Conformance test report of an

AIS system

Equipment under test: **McMurdo**

Test Report No.: 734.2/0066/2003/S3220

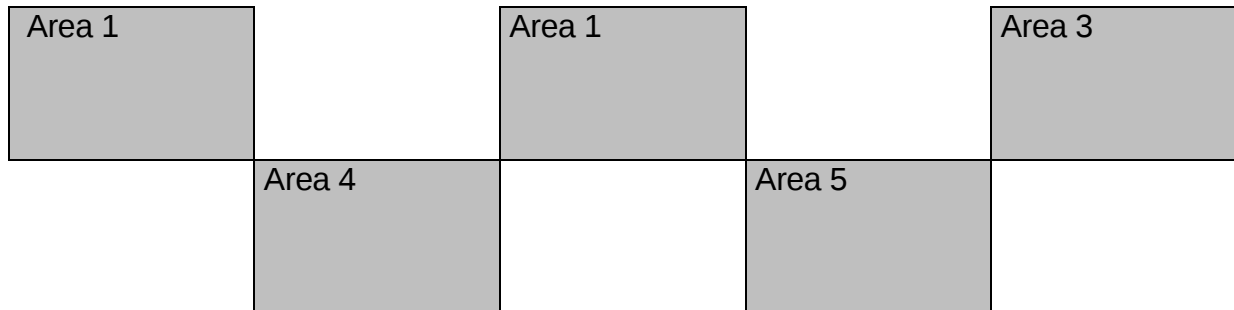
29.10.04	A change of the SW corner of Area 1 (in the picture below) is not accepted (from 51°00 51°05). There is a TXT output from transponder that there are too many corners within a range of 8 Nm <u>Retest 10.11.04 Ba:</u> Change of area is accepted now	Ok

Note) accepted areas

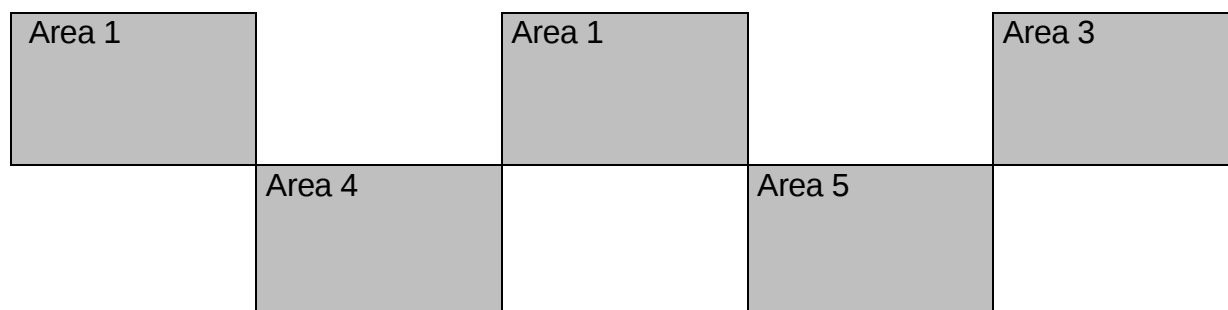
01.10.04 Ba	Area acceptance	Areas No 4 and 5 as shown in "Note) accepted areas" are not accepted <u>Retest 29.10.04 Ba</u> Areas are accepted now	Ok
25.10.04 Wa	Area handling	After the message "channel managment parameter change" the msg "all transmissions enable" and "own reports disable" pop up . Why "own reports disable" <u>Remark 29.10.04 Ba:</u> These TXT message are output because the Tx is disabled for some time to build up a slot map on the new channels and then the Tx are enabled again	Ok
